RE: Hillsborough County Southeast County Landfill
Facility Final Build-Out Conceptual Environmental Resource Permit Application
Response to Request for Additional Information
File No. 29-0270881-004

**SOUTHEAST COUNTY LANDFILL
FACILITY FINAL BUILD-OUT
CONCEPTUAL ENVIRONMENTAL
RESOURCE PERMIT APPLICATION**

RESPONSE TO REQUEST FOR ADDITIONAL INFORMATION

**RESPONSE TO FDEP
REQUEST FOR ADDITIONAL
INFORMATION**

CONTROL STRUCTURE LOCATIONS

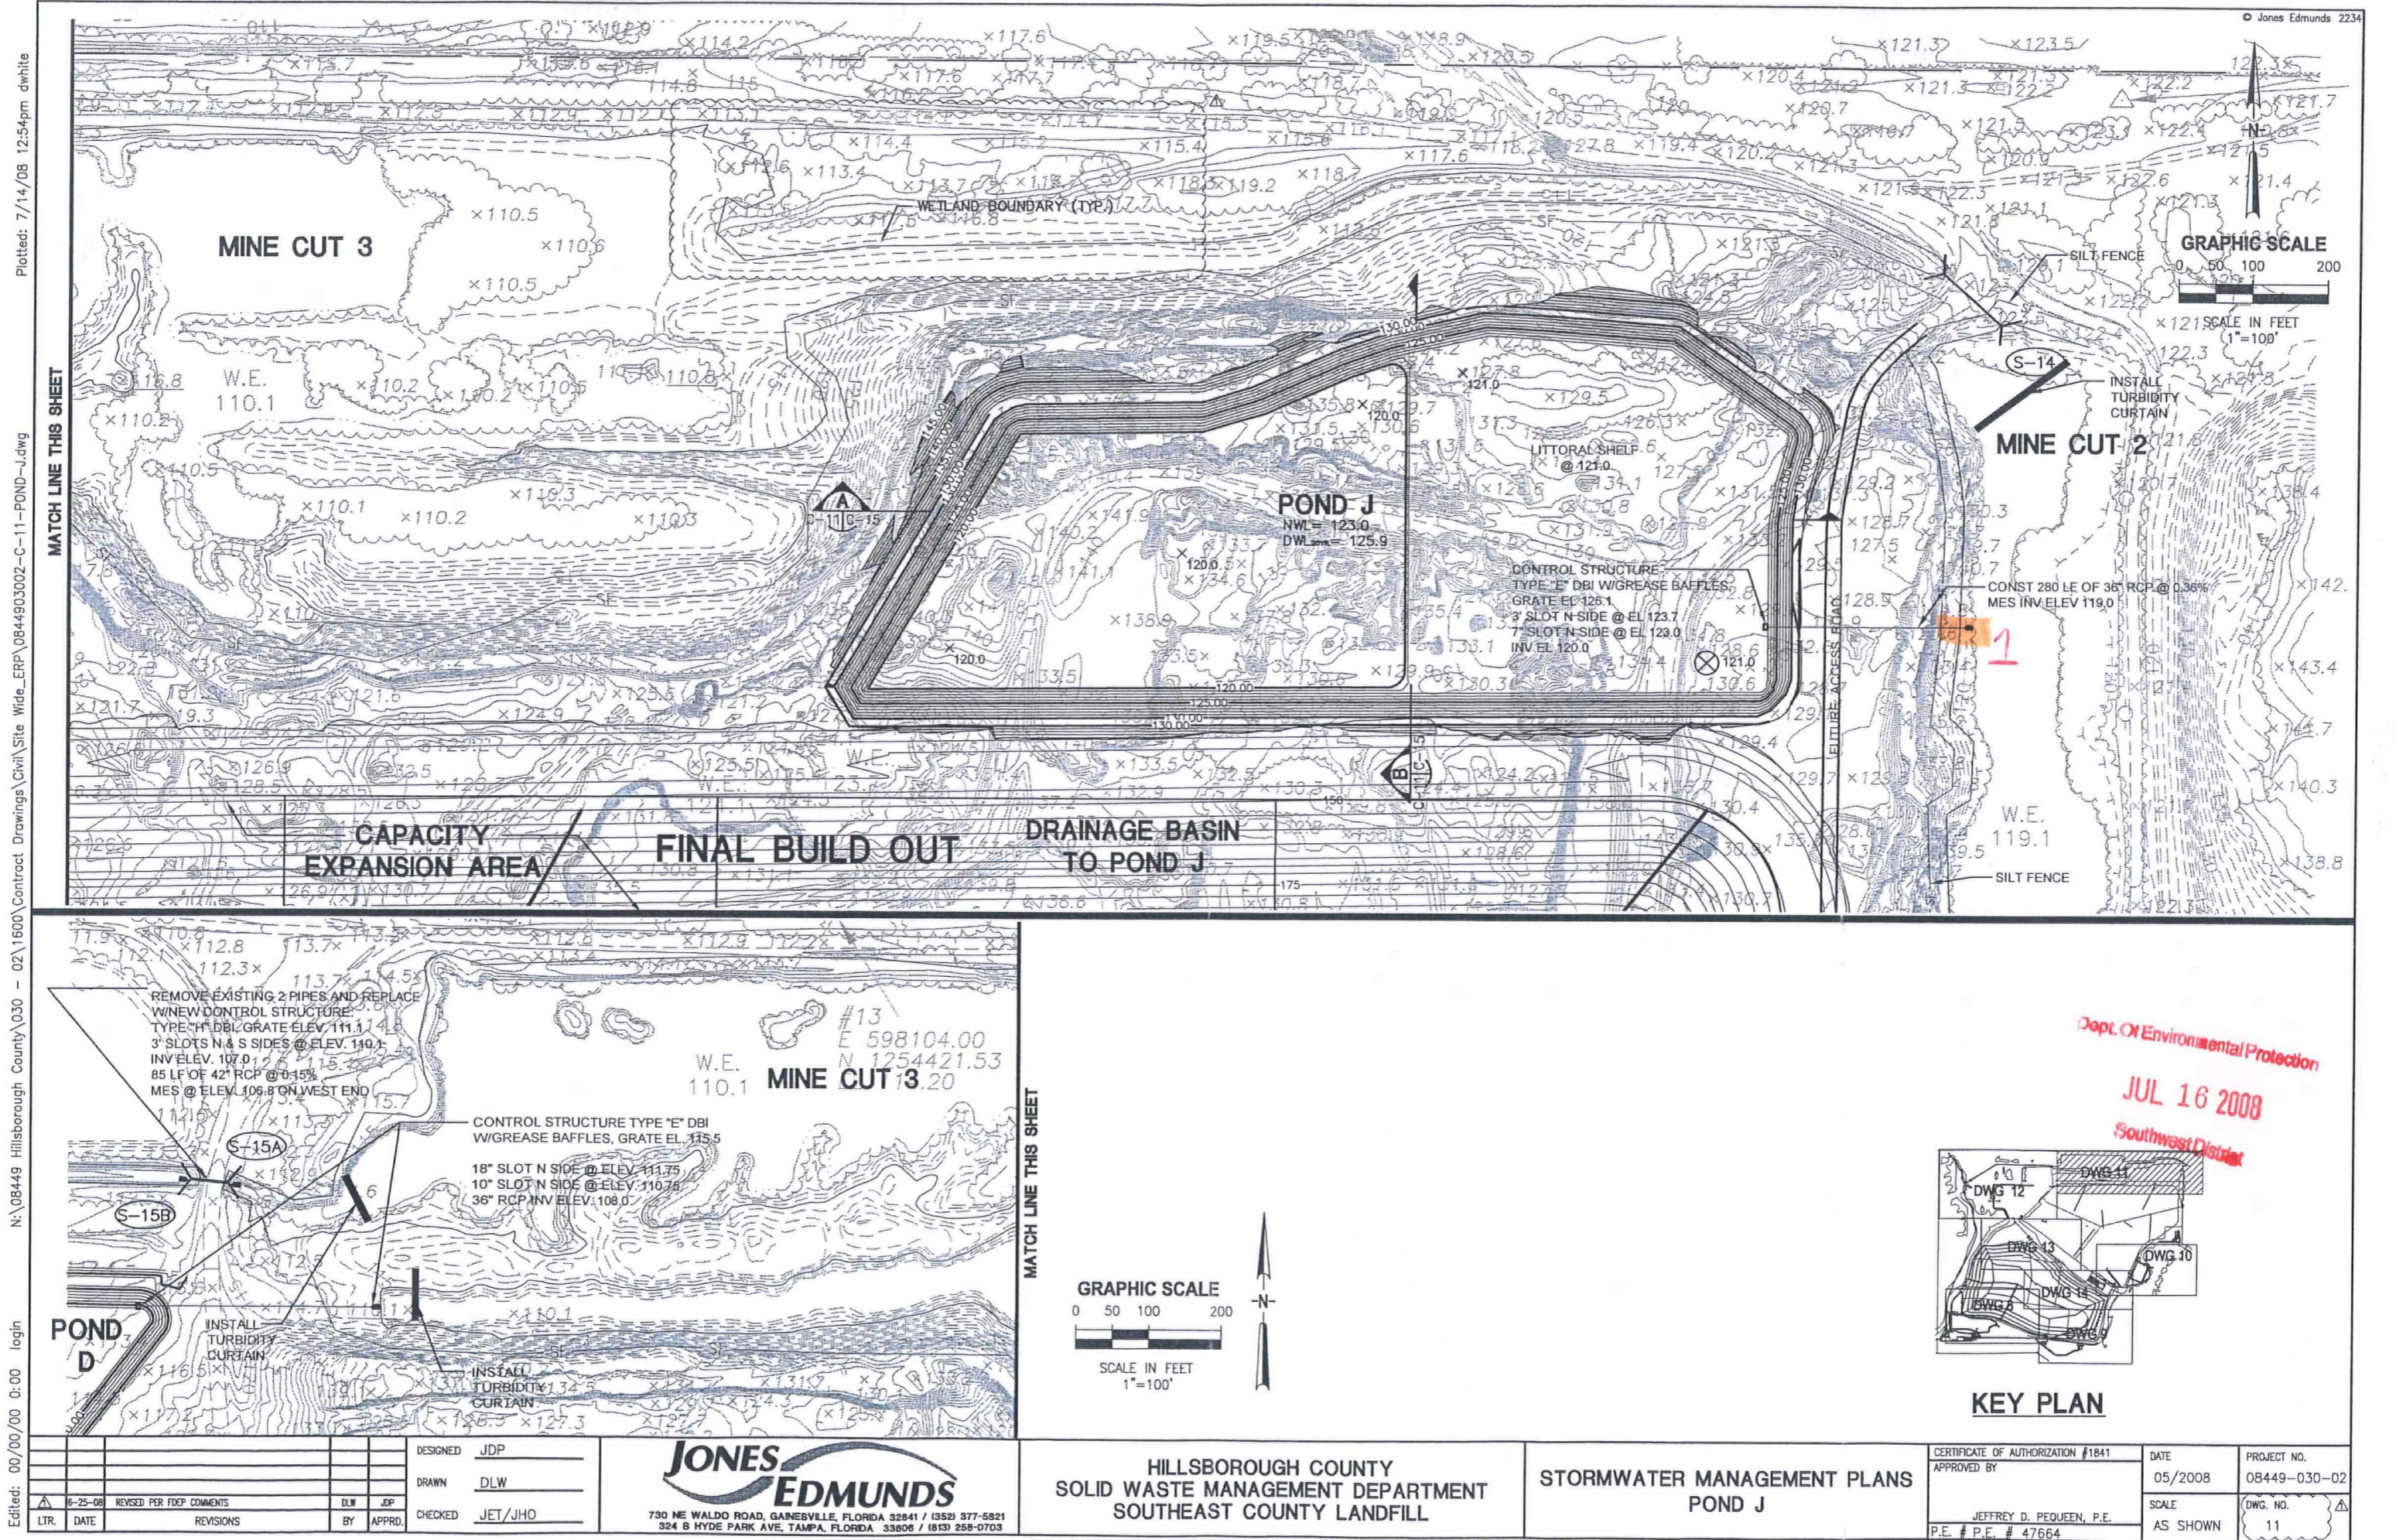
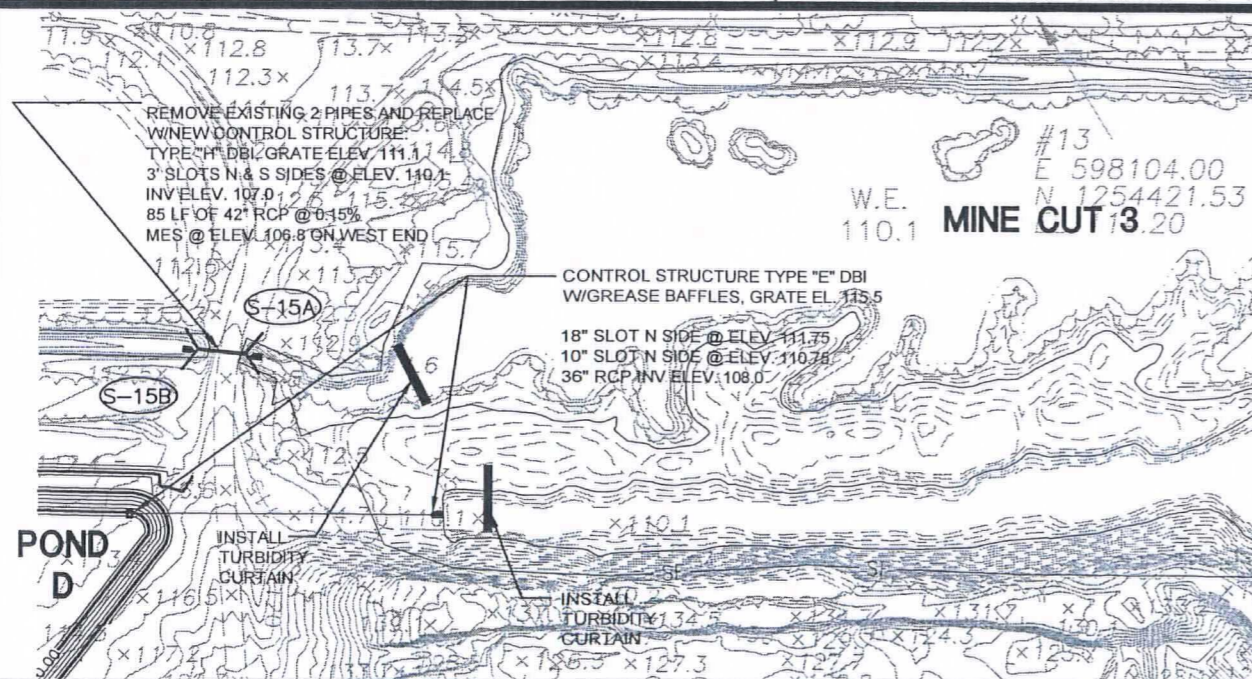
Comment 3: Please show the location of the seven control structures on a plan view drawing and an aerial drawing. Please refer to Application Section E, Part III.

Response 3: The seven control structure locations are highlighted in the drawing provided in Attachment 4.
